Havant Thicket Main Pipeline Works

Non-Material Amendment Technical Note

Rev: S4.P02

Document Status: S4
Document Reference: HTR-WAB-PI-ZZ-TN-W-0016

Figure 1: Tunnel arrangement at shaft interfaces for the fill pipeline: (a) approved scheme, (b) new concrete pressure pipe.

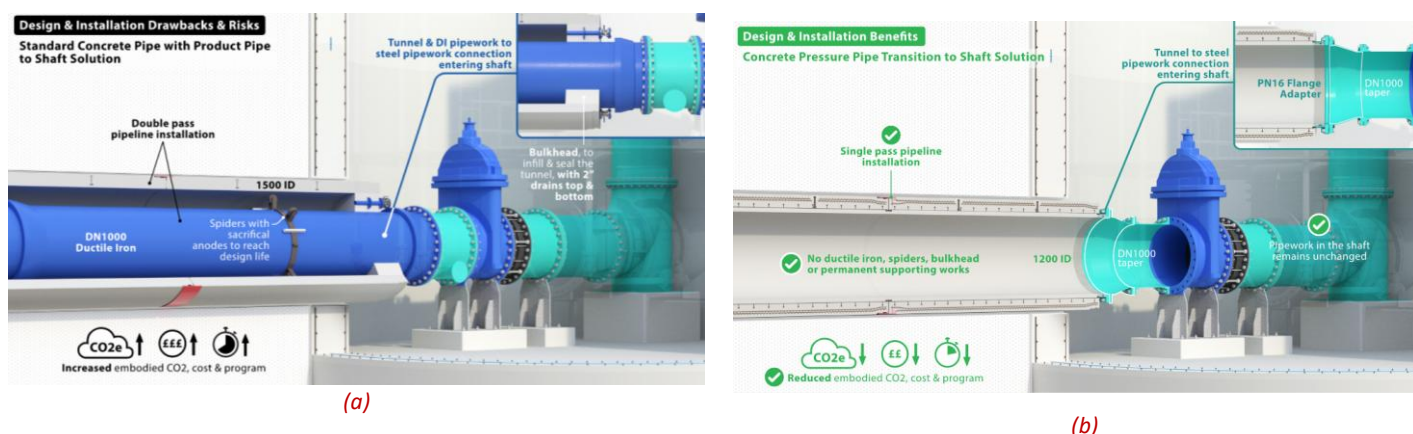
The approved tunnelling solution for the Havant Thicket Main Pipeline involved installing ductile iron (DI) pipework inside a reinforced concrete (RC) jacking tunnel, delivered as a 'two pass' - construction method, as shown in Figure 1 (a). First, a structural RC tunnel was constructed using pipejacking, and once the tunnel drive was completed, the DI carrier pipe was installed within it. This approach required internal supports (called pipe spiders) to position and align the DI pipe inside the tunnel, as well as jointing operations of the DI pipework in a confined, underground environment. The RC tunnel carried all external ground and traffic loads, while the DI pipe inside carried the internal water pressure. Although effective and commonly used, this system introduced additional complexity, risk, embodied carbon, and construction cost due to the duplicated structural and hydraulic systems needed to achieve the final pipeline function.

In contrast, the revised approach uses a 'single pass' - Concrete Pressure Pipe (CPP), in which the pipeline itself is jacked into place and simultaneously fulfils both the structural and hydraulic roles, as shown in Figure 1 (b). The CPP incorporates a continuous welded steel pressure liner, surrounded by a thick reinforced concrete wall capable of taking all external ground loads and jacking forces during installation. Each joint includes a steel-to-steel weld for pressure continuity, supplemented by gaskets providing a watertight seal during construction. Because the CPP acts directly as the permanent pressure pipeline, the need for a secondary DI pipe installation within a tunnel is eliminated entirely and the system is more efficient.

Figure 2: Plan view showing the permanent structure at the emergency discharge site, (a) approved scheme (extract from HTR-WAB-PI-ED-DR-T-0004 A4.P04), (b) updated scheme accommodating the increased water pressures with key changes highlighted.

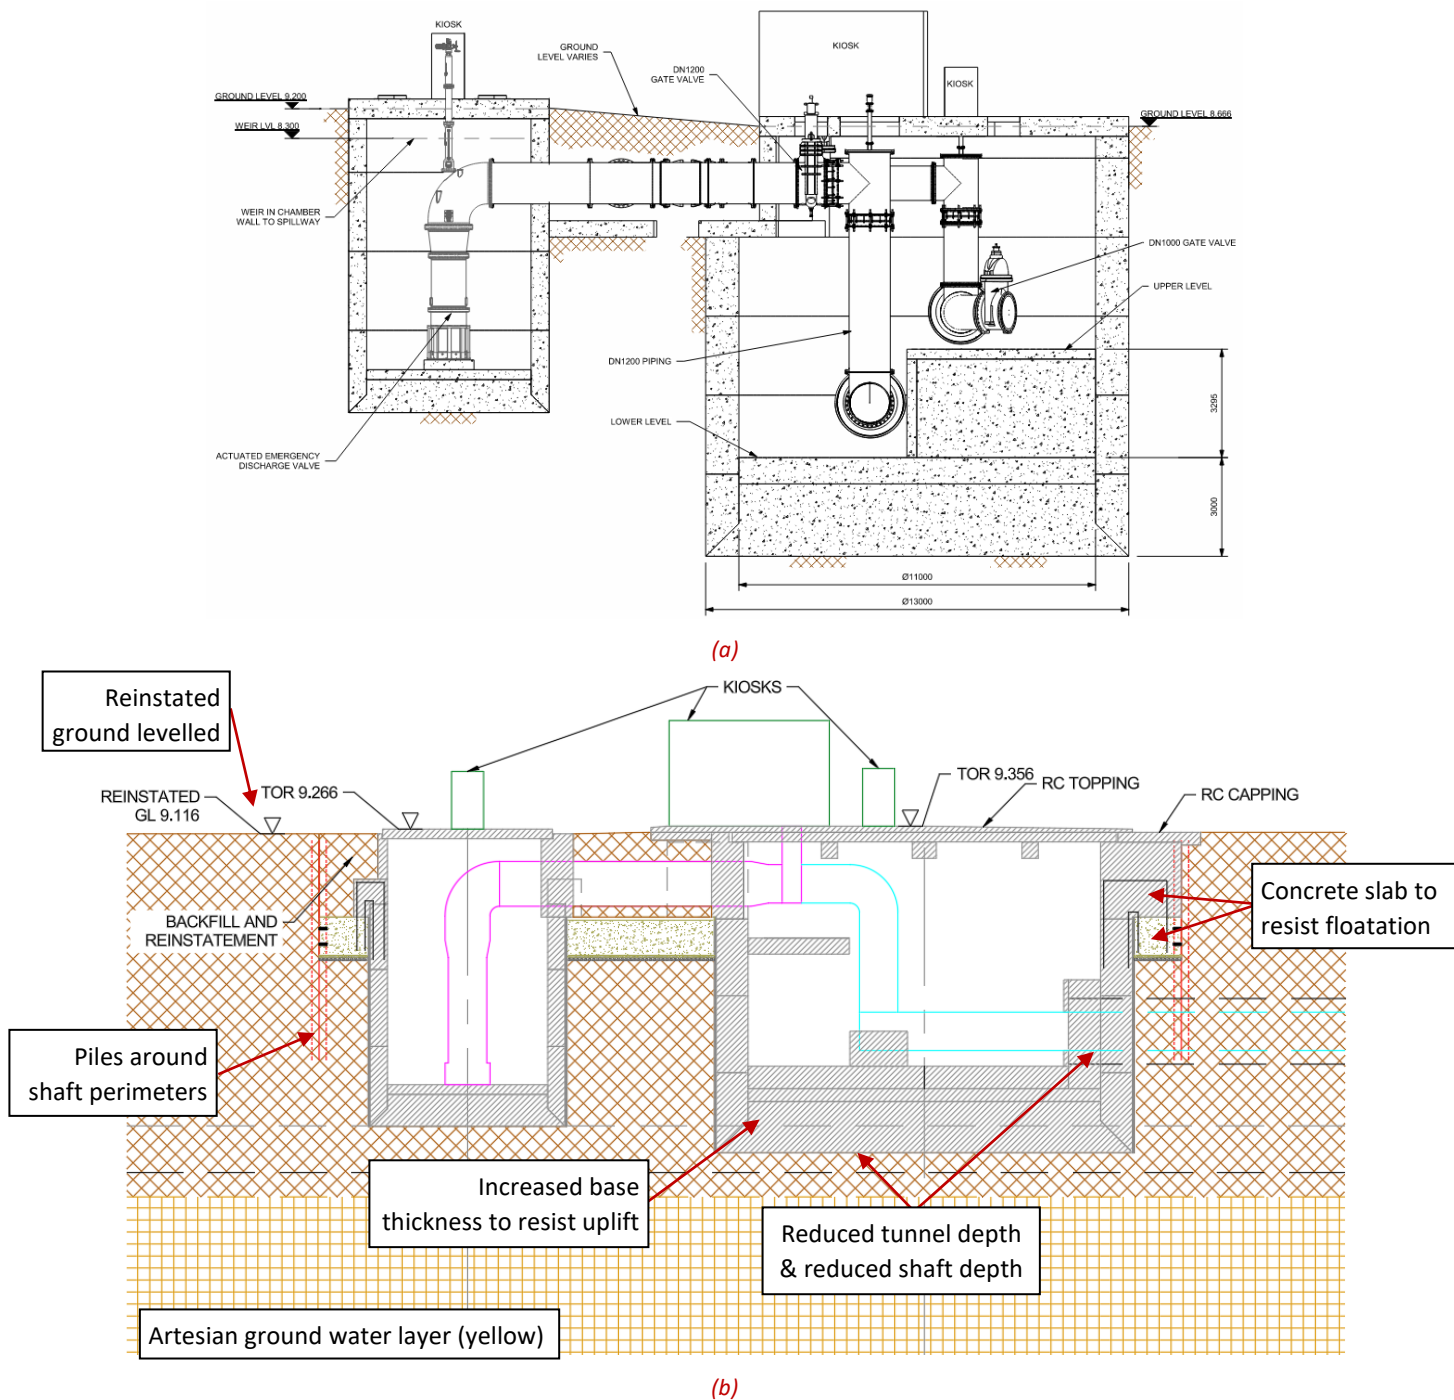
To mitigate against these risks, a dewatering scheme has been introduced at shafts 4 and the emergency discharge site to reduce the ground water pressure during construction and allow the operations to be conducted without the risk of frac out at these locations. Additionally, the design of the shafts at the emergency discharge site has been changed to provide additional mass to resist the uplift forces in the permanent state.

To achieve this at the emergency discharge site, the tunnel alignment depths have been reduced, to ensure the shaft and tunnels are not within the artesian layer. Additional piling has also been introduced to allow for safe construction of a larger slab around the shafts to resist uplift caused by the increased water pressure. Furthermore, the thickness of the shaft bases has been increased to provide additional mass within the shaft and provide a stronger base, which can resist the increased loading. These changes are shown in Figure 2. Figure 3 shows a plan view of the piled arrangement around the emergency discharge site shafts. The arrangement has been designed so that it can be installed using silent piling methods.

In addition to the above changes, the ground level strategy has been changed slightly so that the whole site is now level after reinstatement (instead of having a rise in it at the discharge shaft). This change reduces the need to import fill and simplifies site access requirements, thereby removing health and safety risks during site operation.

Figure 4: Plan view showing the buried structures at shaft W6 with piles highlighted in green: (a) approved scheme (extract from HTR-WAB-PI-W6-DR-T-0001 A4.P04), (b) updated scheme cofferdam.

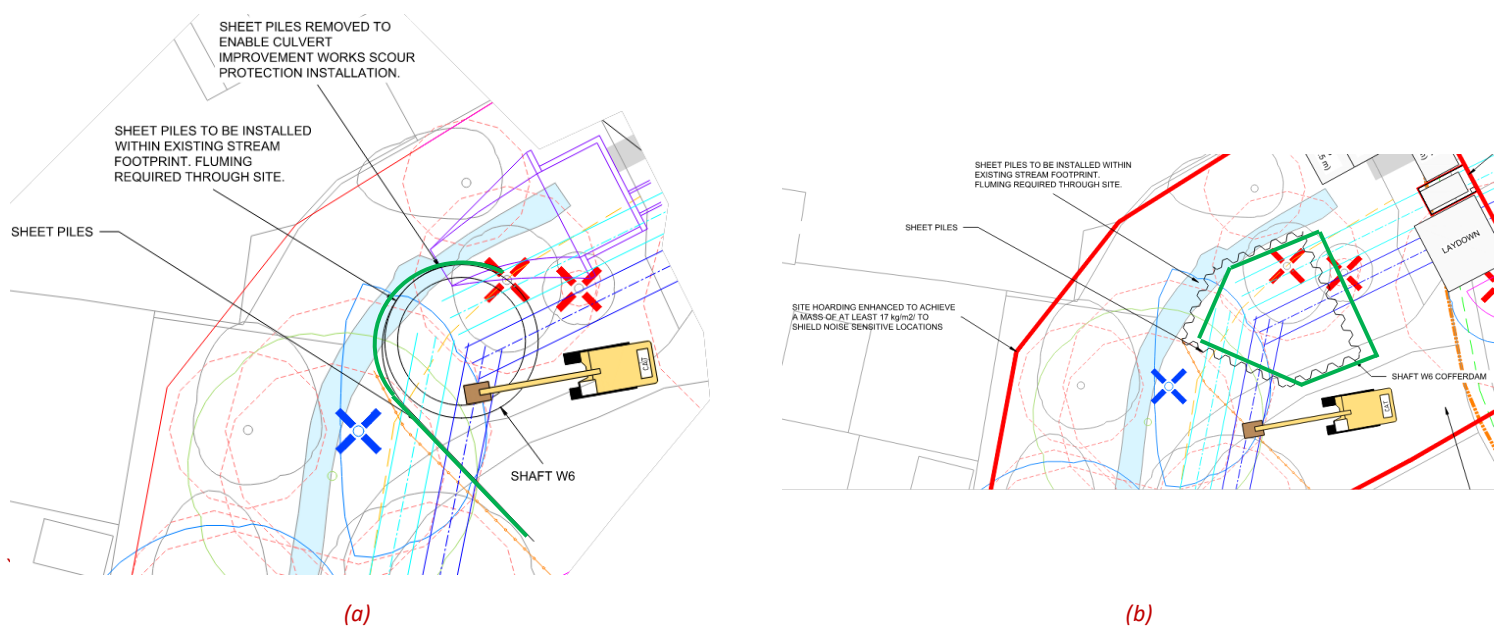
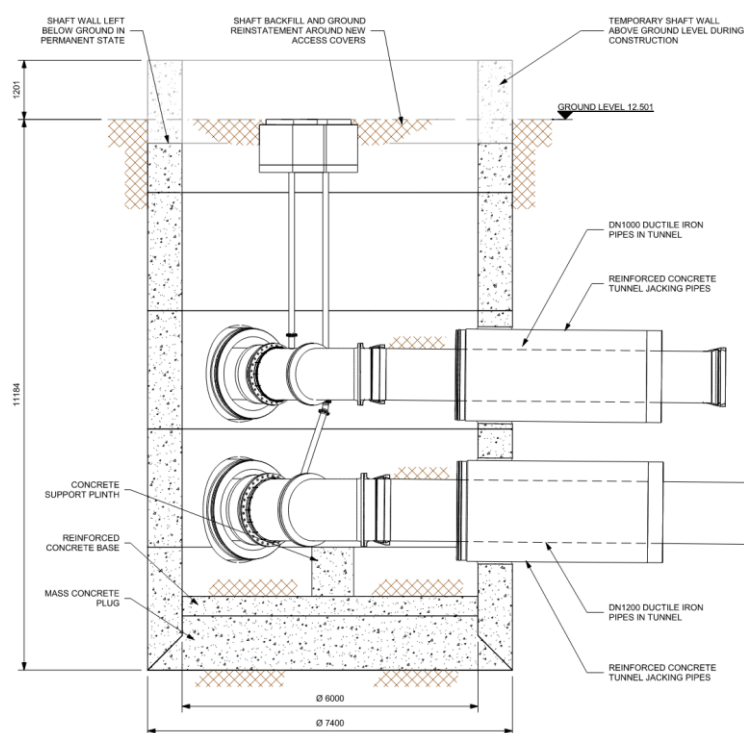
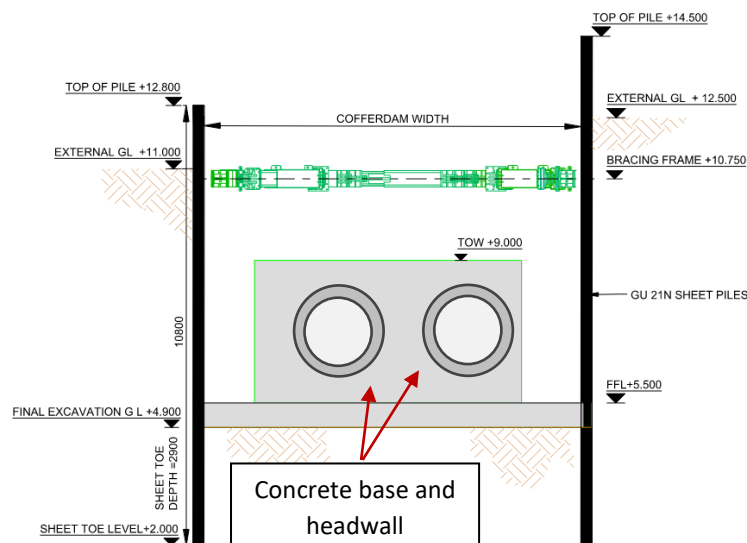
The Shaft W6 construction site is the most physically constrained site along the pipeline route. Riders Lane stream to the north and west of the site location, Dunsbury Way to the east, and houses to the south limit the available site footprint and introduce constraints on the location of the shaft footprint to avoid blocking the stream. These constraints, coupled with the changes in tunnel alignment discussed in Section 3, mean that a circular caisson shaft construction is no longer suitable for the construction of shaft 6. Instead Shaft W6 will need to be constructed using a cofferdam with a reinforced concrete base, as shown in Figure 4.

The figure shows that the revised cofferdam arrangement does not provide any greater blockage to the stream than the approved proposal and does not significantly change the footprint of the shaft. Instead, the change has been made to “square off” the circular shaft, to provide increased internal working room for tunnelling and pipework operations within the shaft. Figure 5 shows a comparative section through the shafts, which highlights that the depth (and therefore volume of excavated material) has also been reduced by the proposed change, as well as the reduced volume of concrete required in the cofferdam arrangement.

Figure 2 – Proposed scheme accommodating the increased water pressures with key changes highlighted.

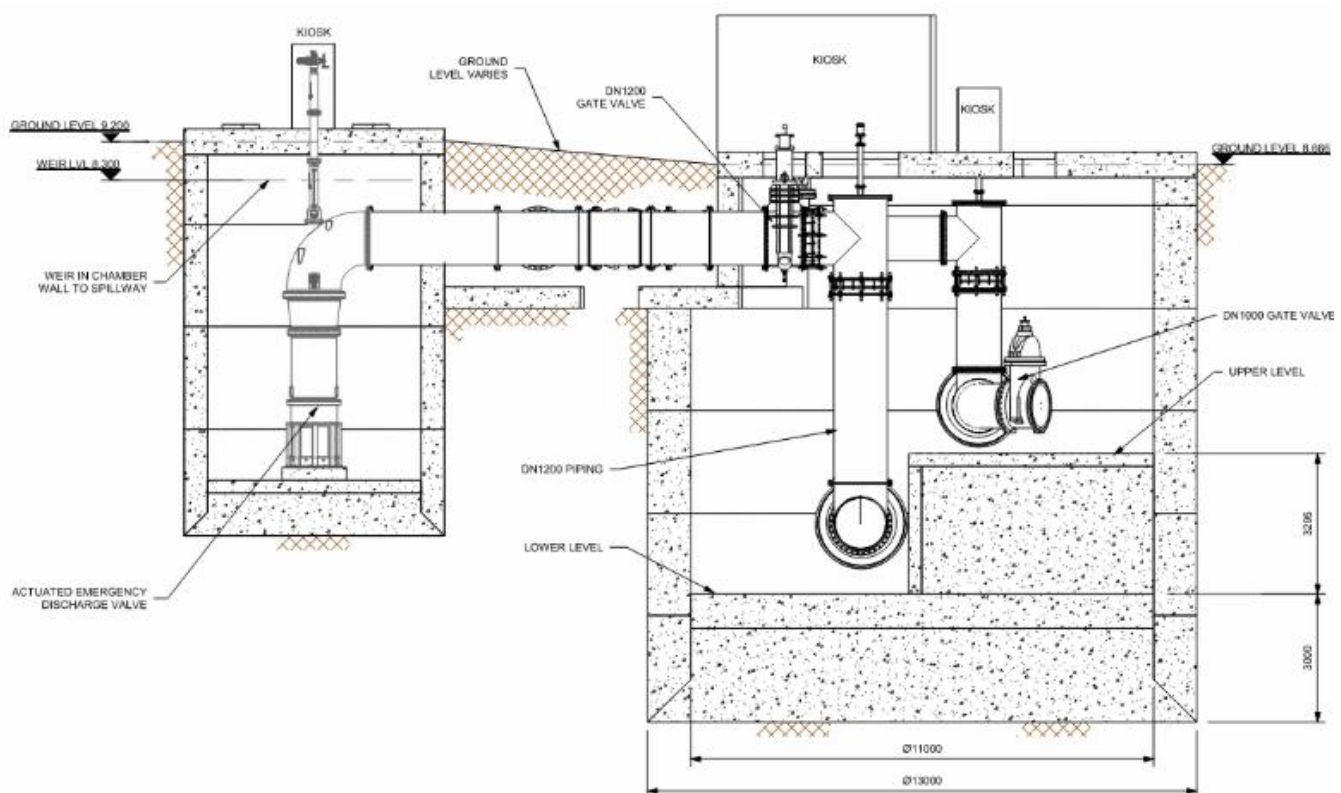
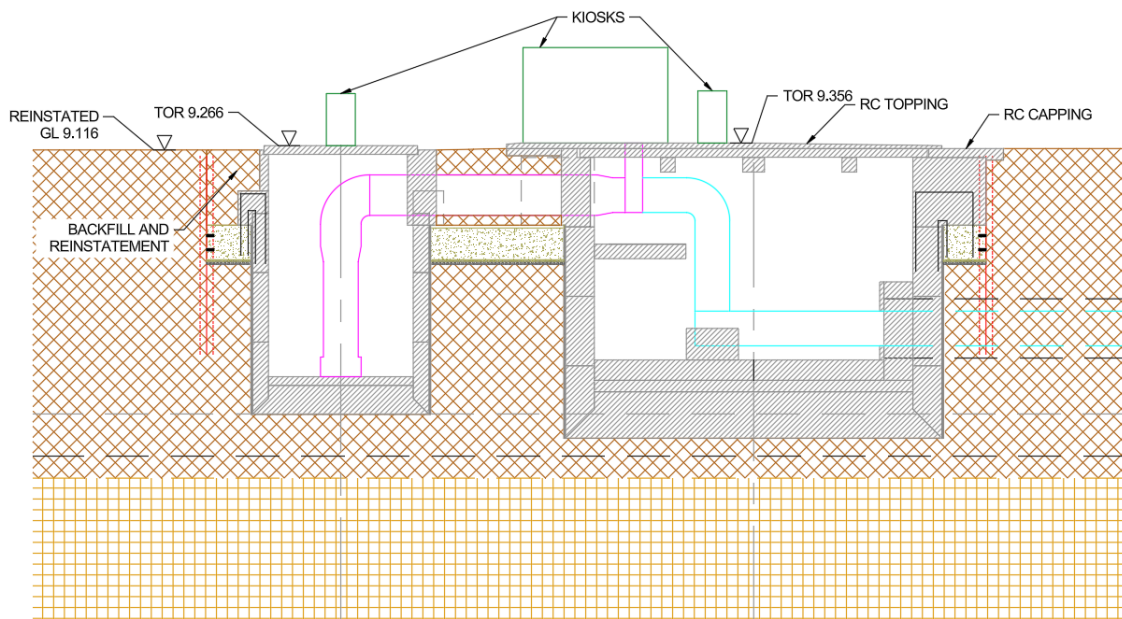
To mitigate these risks, a dewatering scheme has been introduced at the emergency discharge site to reduce the ground water pressure during construction and allow the operations to be conducted without the risk of frac-out – which is the unintentional return of drilling fluids to the surface – at these locations. Additionally, the design of the shafts at the emergency discharge site has been changed to provide additional mass to resist the uplift forces in the permanent state.

To achieve this at the emergency discharge site, the tunnel alignment depths have been reduced, to ensure the shaft and tunnels are not within the artesian layer. Additional piling has also been introduced to allow for

safe construction of a larger slab around the shafts to resist uplift caused by the increased water pressure. Furthermore, the thicknesses of the shaft bases have been increased to provide additional mass within the shaft and provide a stronger base, which can resist the increased loading. These changes are shown below in Figure 1 and Figure 2. Figure 3 shows a plan view of the pile arrangement around the emergency discharge site shafts. The arrangement has been designed so that it can be installed using silent piling methods.

In addition to the above changes, the ground level strategy has been changed slightly so that the whole site is now level after reinstatement (instead of having a rise at the discharge shaft). This change reduces the need to import fill and simplifies site access requirements, thereby removing health and safety risks during site operation.

Figure 4 - Plan view showing the buried structures at shaft W6 with piles highlighted in green: (a) approved scheme (extract from HTR-WAB-PI-W6-DR-T-0001 A4.P04), (b) updated scheme cofferdam.

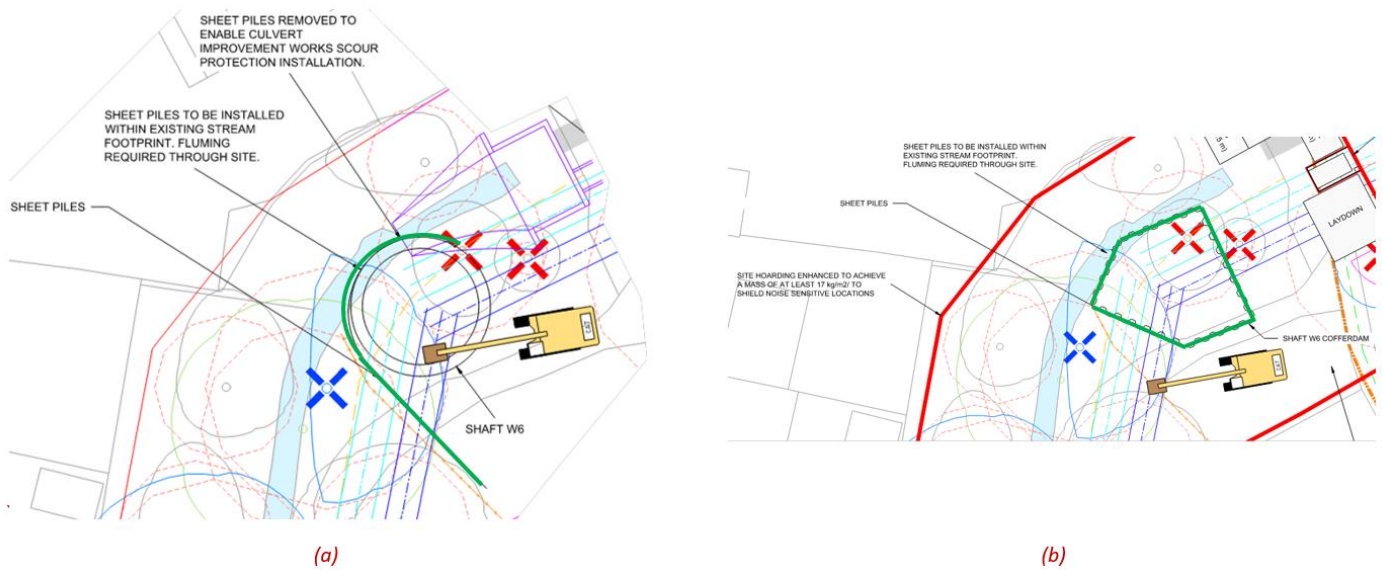
The shaft 6 construction site is the most physically constrained site along the pipeline route. Riders Lane stream to the north and west of the site location, Dunsbury Way to the east, and houses to the south limit the available site footprint and introduce constraints on the location of the shaft footprint to avoid blocking the stream.

These constraints, coupled with the changes in tunnel alignment discussed above on the Emergency Discharge structure, mean that a circular caisson shaft construction is no longer suitable for the construction of shaft 6. Therefore, it is proposed that shaft 6 will need to be constructed using a cofferdam with a reinforced concrete base, as shown below in

Figure 5 - Section view showing the buried permanent structure at shaft W6: (a) approved scheme (extract from HTR-WAB-PI-W6-DR-T-0002 A4.P04), (b) updated scheme. Note that the scales on the section views are different.

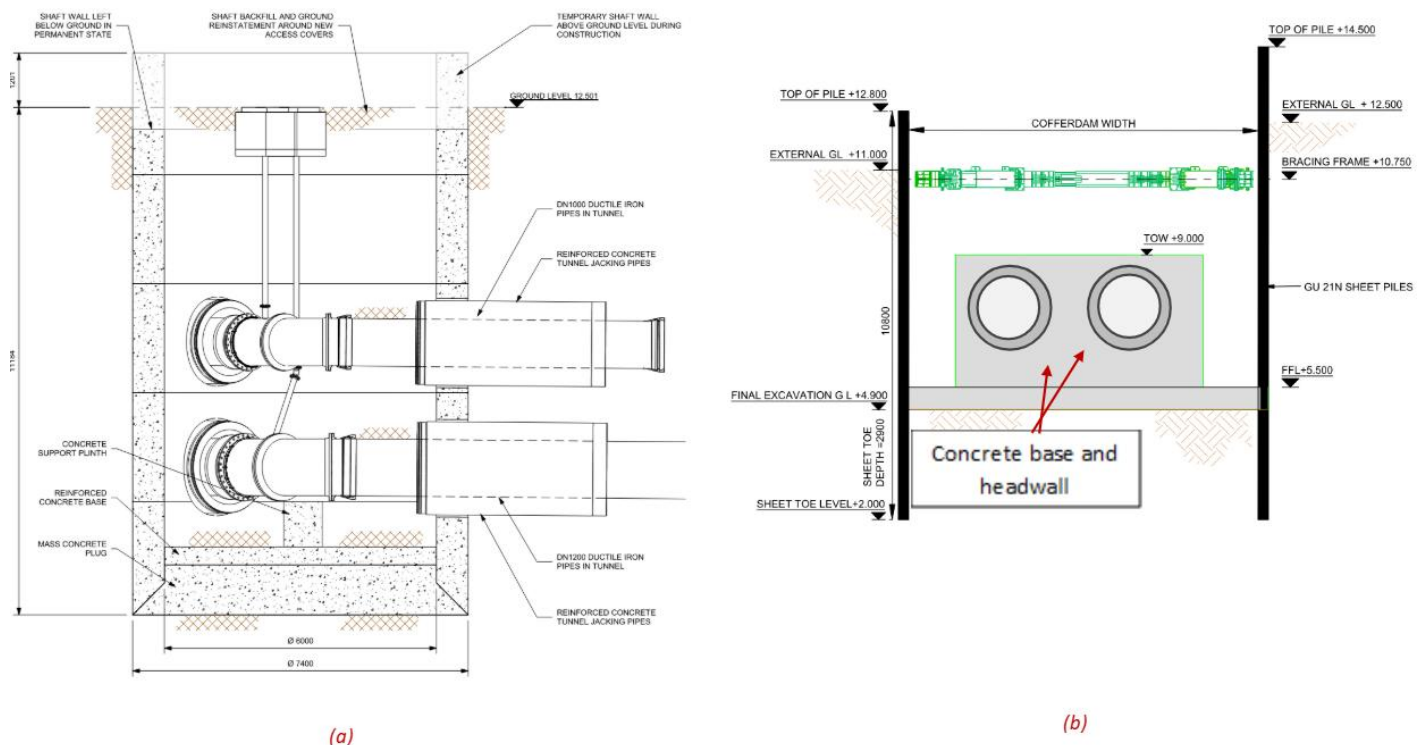
The change in construction method at shaft 6 means a reduction of reinforced concrete, however it does result in a slight increase in the length of pile wall to be installed and a minor increase in the volume of excavated material. These changes are summarised in Table 5. The increase in sheet pile length created by the straighter alignment of the piles allows more of the piling to be completed using silent piling methods, whereas 50% of the approved scheme was required to be installed using vibratory methods due to the curved nature of the sheet pile wall. The reduction in concrete volume equates to an approximate 34 T CO2e reduction in embodied carbon at the shaft 6 site, whereas the increase in sheet pile length causes a 16 T increase in CO2e at the site.

Figure 1: Shaft 6 piling extents shown in green. Consented (left) and proposed (right). Taken from Figure 4 of the WAB NMA Technical Note (2026).

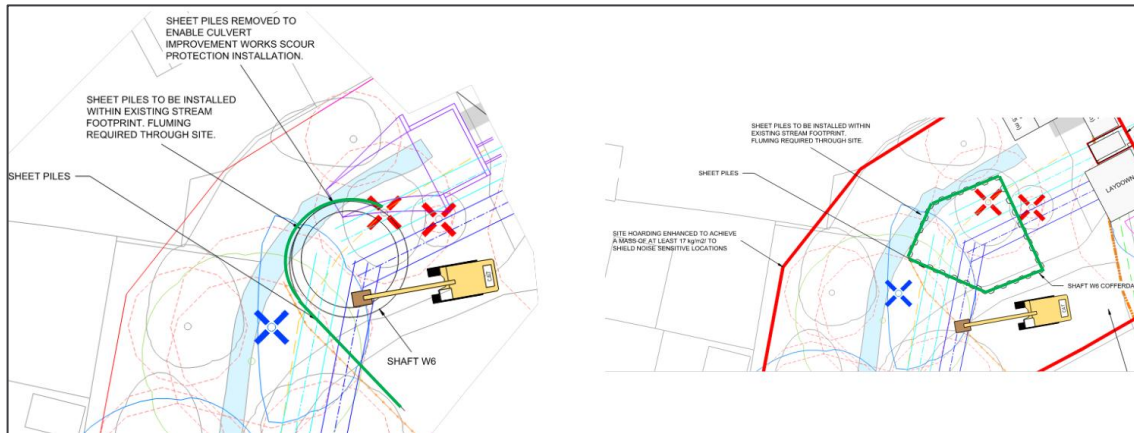
There is a small increase in the length of the pile wall; however, the revised design enables a greater proportion of the works to be carried out using silent piling techniques. As silent piling (hydraulic jacking) is more than 10 dB quieter than vibratory piling, this change will not result in an increase in construction noise or vibration levels.

Figure 1 presents the consented (left) and proposed (right) piling alignments and extents for Shaft 6. Figure 2 presents the consented (left) and proposed (right) piling alignments and extents for Shaft ED.
